ADDENDUM NUMBER 3

MILWAUKEE COUNTY
ZOOLOGICAL GARDENS
PARKING LOT 1 AND WALKWAYS
RE-PAVING & LIGHTING
10001 West Blue Mound Road
Site #355
Milwaukee, WI 53226

Project Number: Z083-11631
Notice Number: 6872

Date of Addendum: December 9, 2013

CONC. PAVEMENT CONSTRUCTION JOINT DETAIL (SLIP-JOINT)

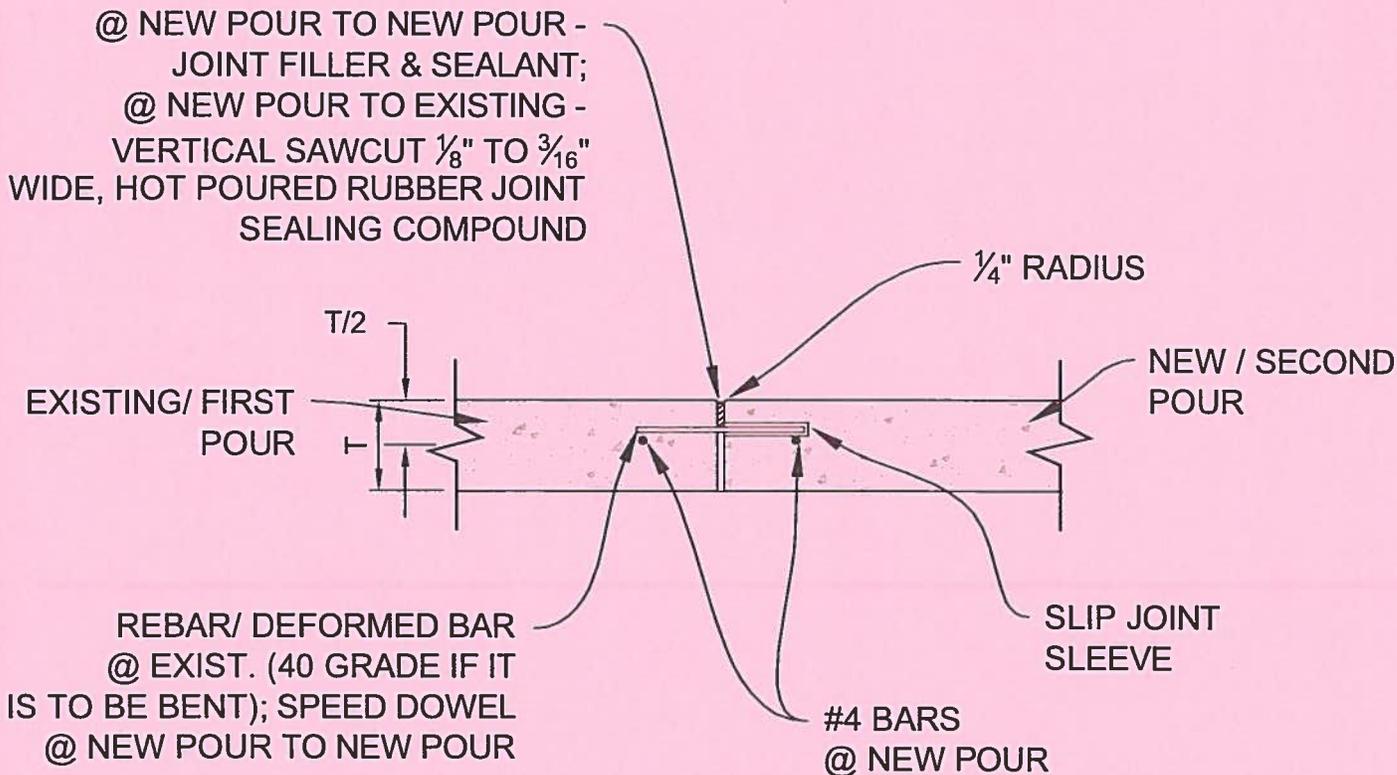
- 12) Detail 4/111 – Add note on backside of curb to read "EXPANSION JOINT FILLER AND SEALANT."
- 13) Detail 5/111 – Add note on backside of curb to read "EXPANSION JOINT FILLER AND SEALANT."
- 14) Detail 5/111 – Change 12" height on gutter side to 7".
- 15) Detail 6/111 – Add note on backside of curb to read "EXPANSION JOINT FILLER AND SEALANT."
- 16) Detail 7/111 – Replace drawing with SKT003 dated 12/09/2013 attached to this Addendum 3.
